Docket Item # 2
BAR CASE # 2011-0052

BAR Meeting
April 6, 2011

ISSUE: Alterations (Window Well Installation)

LOCATION: 917 South Saint Asaph Street

Figure 4. Proposed Basement Plan

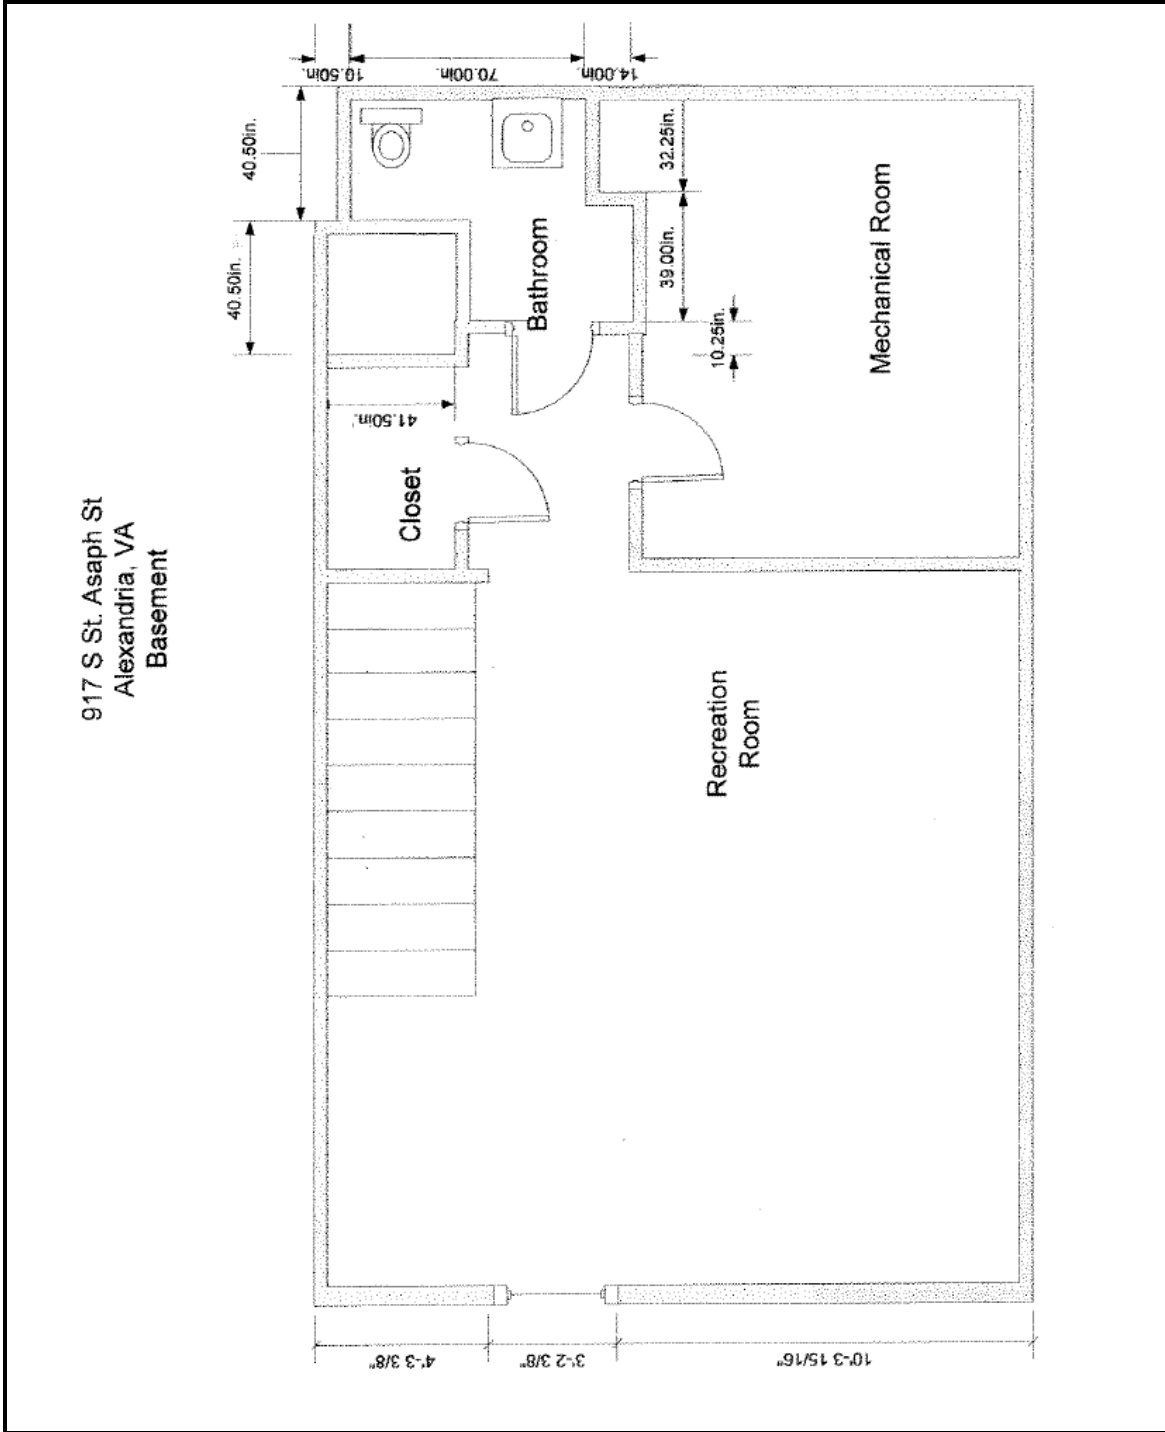
C3 At a minimum the plans shall include the existing basement floor plan and all proposed alterations to the basement including ceiling height, any new partitions, all plumbing fixtures and information of appliances enclosed in the “mechanical room”

Figure 8. Proposed Cross-Section

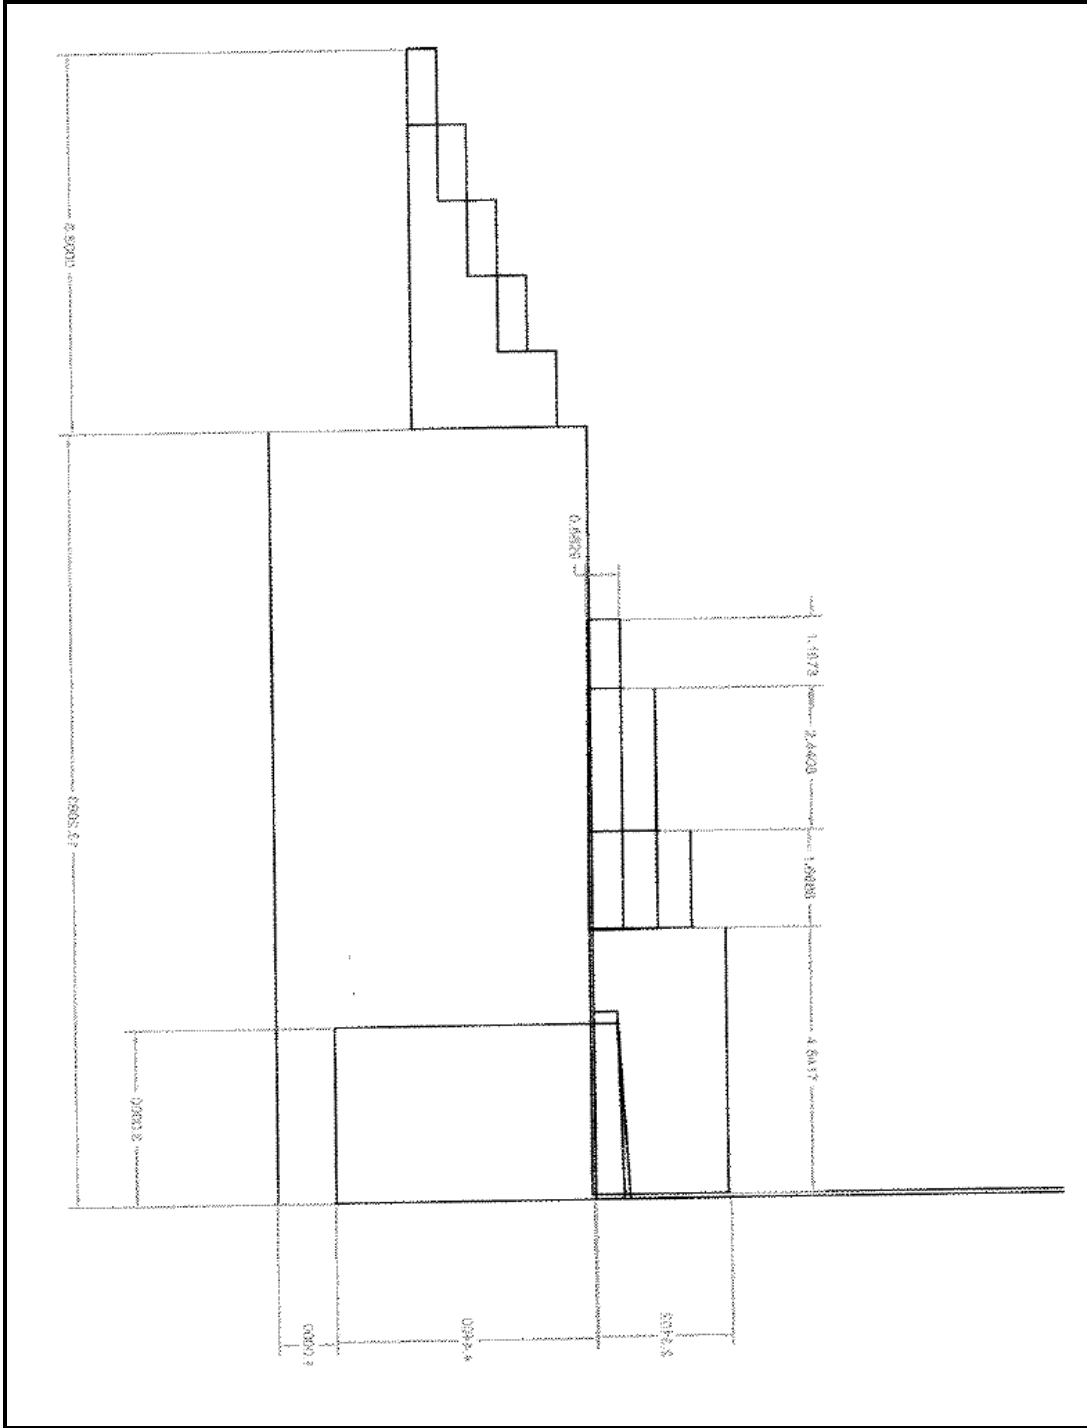
C4 Emergency egress window and well shall conform to 2009 VA VCC section R310 as amended.
